From: [REDACTED]
Sent: Friday, September 10, 2021 9:37 PM
To: Kessler, John
Subject: CASE NO. PL19-0039--Board of Supervisor Hearing, September 14, 2021, 3 p.m.
Attachments: Well #7 capital project white paper 180619.pdf; 24 Jan 2019 staff rpt on Well #4 Options .pdf

RE: CASE NO. PL19-0039-Board of Supervisor Hearing, September 14, 2021, 3 p.m.

COMMENTS ON CRESTVIEW'S PROPOSED WELL 7

EXHIBIT "A"

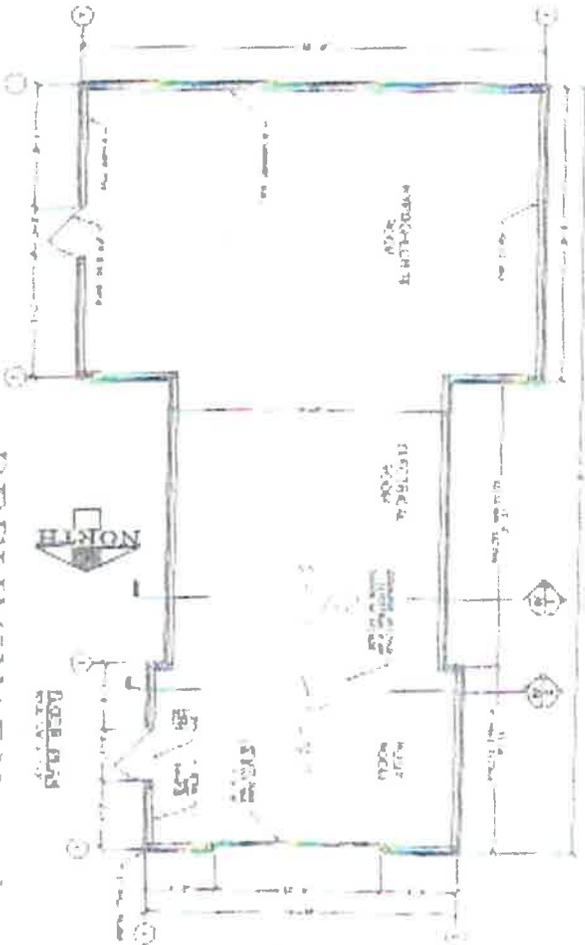
Crestview Mutual Water District Architectural Committee Grounds for Denial:

- Article VIII, Section 1, page 36- Each Lot shall be used exclusively as a private single-family residence. No owner shall use or cause his Lot to be used for any commercial, industrial, storing or other non-residential purposes except citrus or avocado farming.

- Well within 150' of septic systems
- Metal roof is not approved
- No information submitted for chemical storage close to habitable dwellings.
- Buildings do not conform to the aesthetics of the custom homes in the HOA. The proposed buildings do not look like single family homes, Tuff Shed type structure, not wood or stucco structure. Proposed buildings are inharmonious or out of keeping with the general plan of improvements for the Project or with Improvements erected on neighboring lots.

**As Presented to HOA Architectural Committee July, 2021
Same Steel Building, Only in White**

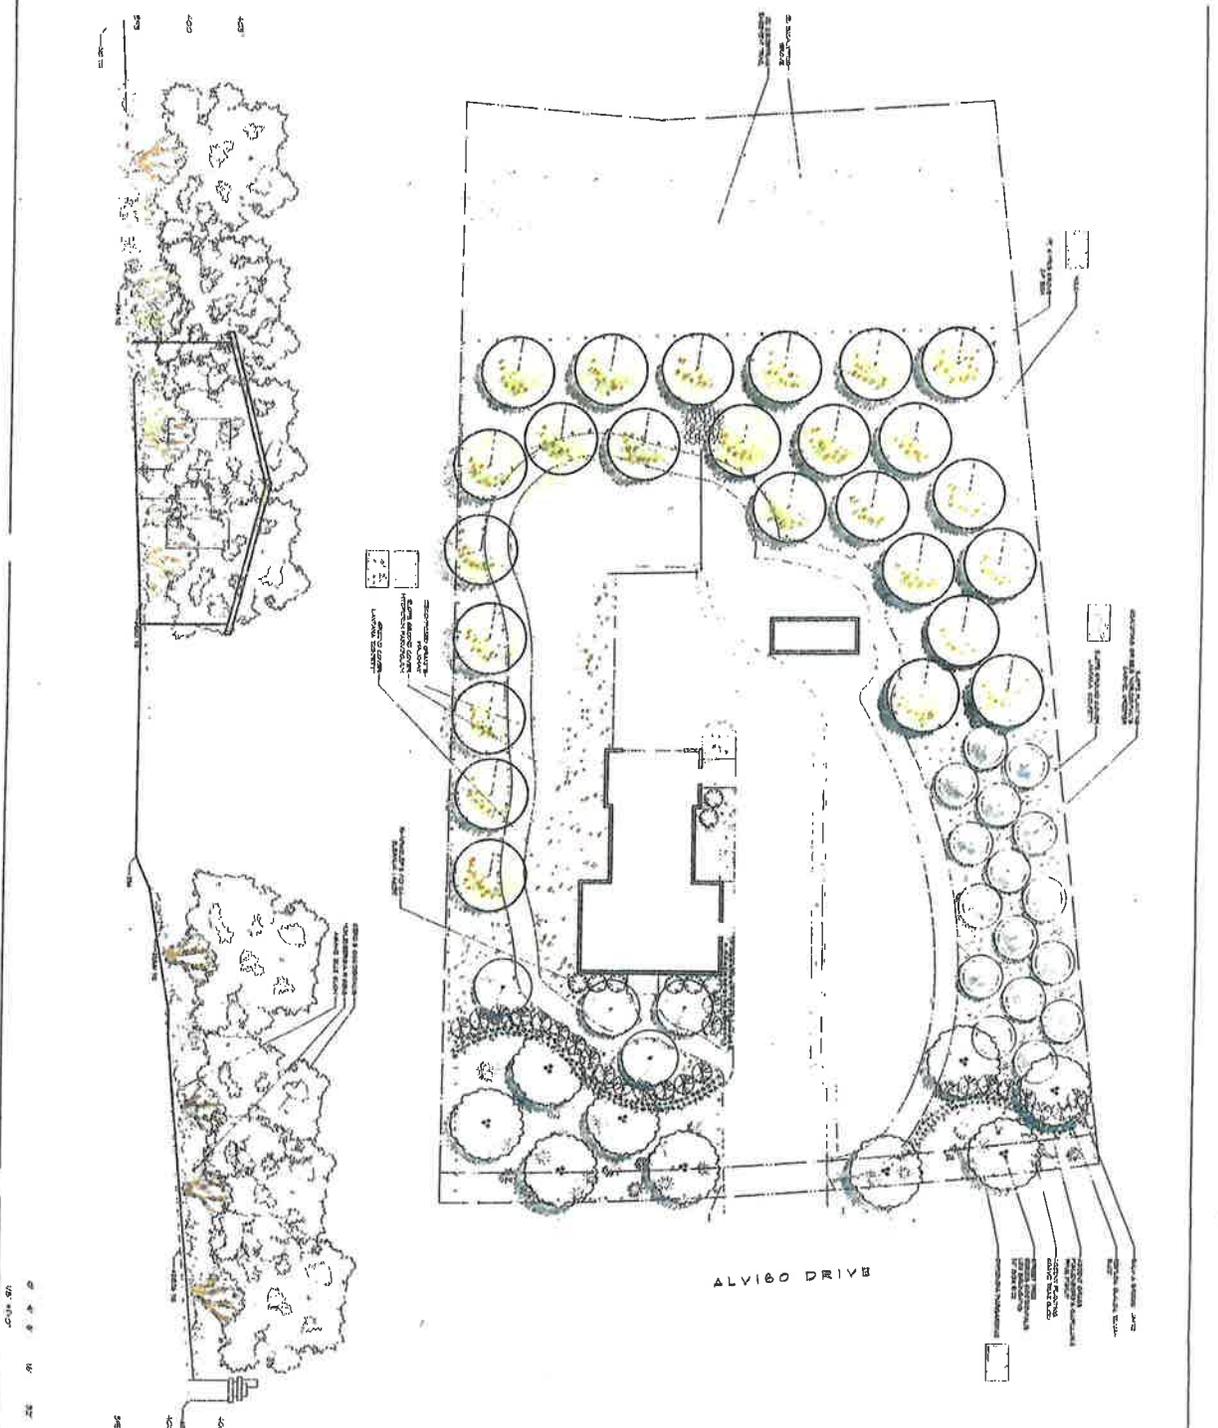
There is no new evidence to contradict the Commission's finding that the development is 'inconsistent with the established covenants, conditions and restrictions of the Las Posas Hill's Owners Association'

Site is too small to drill this size well

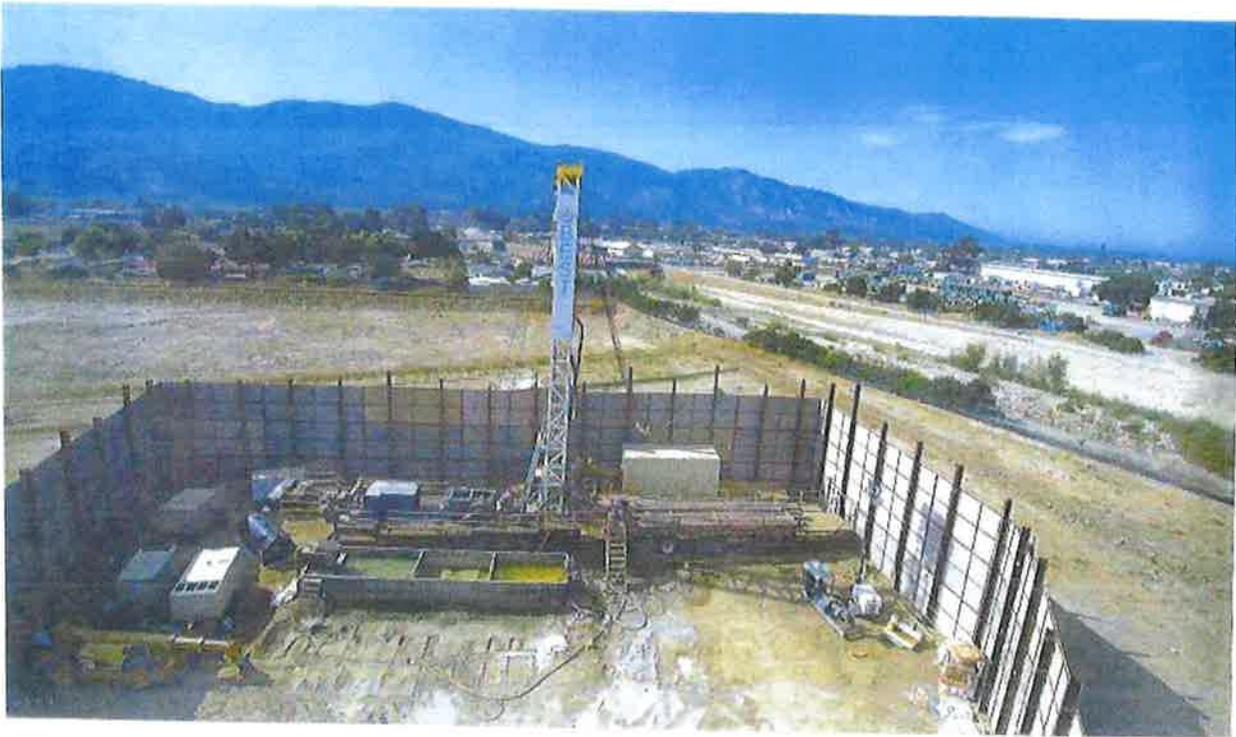
- Lot is 24,000 sq ft. approx. 125 X 190. With blue line creek as northern property line and subtracting the equestrian trail, you have less than 18,000 sq ft left.
- We were told they need a flat 10,000 sq ft pad to drill well. With sound blankets needed 8 ft off the property line, there is even less area to maneuver. Some drilling contractors require an additional 200 X 200 ft. to stage equipment.
- Crestview did not submit plan or apply for a grading permit. The lot has a 23-degree slope from street to blue line creek.
- Other property owners along the blue line creek have double retaining walls. Crestview is not building a retaining wall.
